PLANNING & HERITAGE STATEMENT

41 ARLINGTON ROAD

Ms A Mitchell 41 Arlington Road, London, NW1 7ES

MARCH 2021

Figure 1: Extract from approved plan 99-111A identifying internal vault and boiler room

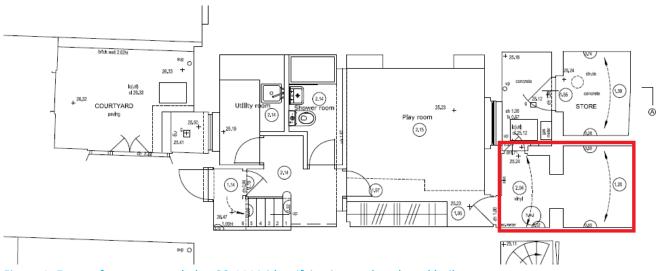
4.3 On the advice of the Applicant's building contractor, application Ref No 2018/6352/L and 2018/6207/P originally proposed to plaster the internal vault walls using lime plaster. However, following comments from the Conservation Officer during determination, it was agreed that this would be omitted from the proposals, with the brickwork made good and the walls left in their natural state. This work has been undertaken and natural ventilation has also been installed as requested by the Conservation Officer. This comprises a stainless-steel adjustable vent in the lightwell door, measuring 210mm x 152mm (please see image below).

- 4.4 Unfortunately, this approach hasn't been successful in keeping the house water-tight and in times of rainfall, the vault and boiler room experience an extreme influx of water. Rainwater is able to run freely through the mortar joints and cracks in the existing brick which is causing damage to the original historic fabric, as well as the heating and electrical systems situated within, creating an obvious safety hazard (please refer to photographs at **Document 1**).

- 4.6 A specialist surveyor (Universal Basement Waterproofing Ltd) was therefore instructed to review the problem. They have advised it will be necessary to either Koster the walls or install a breathable waterproof membrane in order to prevent further water damage to the listed building. The latter option is considered to be the most appropriate given the historic setting.

- 4.7 The proposed cavity drained membrane system is a reversible system which will prevent damage to the heritage structure. The proposed system leaves a gap between the existing wall and the new surface which does not prevent the passage of moisture but allows the moisture to escape. Fixings through the membrane are minimal and only 10mm diameter holes are drilled during this process. Please refer to the Survey prepared by Universal Basement Waterproofing Ltd for full details of the proposed waterproofing works as well as a Method Statement.

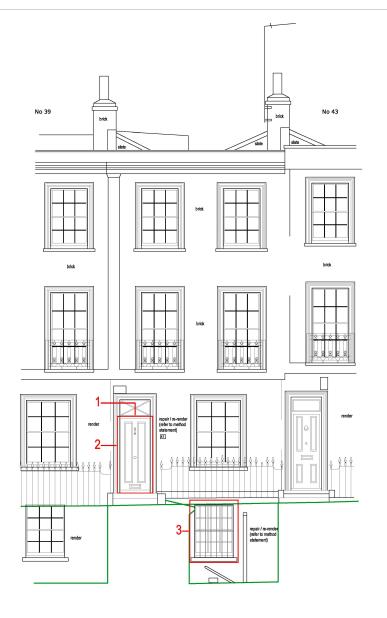
In respect of the rear upper level guttering, we had proposed to reinstate the downpipe on the right hand side rather than the left - I've attached the approved plan (99-31D) and the updated plan (99-31G) which identifies this as item 5. The right hand side was preferred as it prevents any interference with the window. Is this acceptable? If not, I'm sure this can be rearranged.

The replacement/relocation of the rain water pipe on the rear elevation which we discussed. This currently runs across the sash window which is visually obtrusive and unacceptable. As we discussed, the rain water pipe should run to the left hand side rather than the right hand side as it currently does.

Many thanks for confirming that the upper level downpipe should be relocated on the right hand side rather than the left as per your email below. As discussed, an application for Listed Building Consent is being submitted to update the relevant approved plan (99-31D) to show the revised arrangement.

4. Replacement of existing fixed timber window with openable window. 5. Retrospective planning consent being sought.
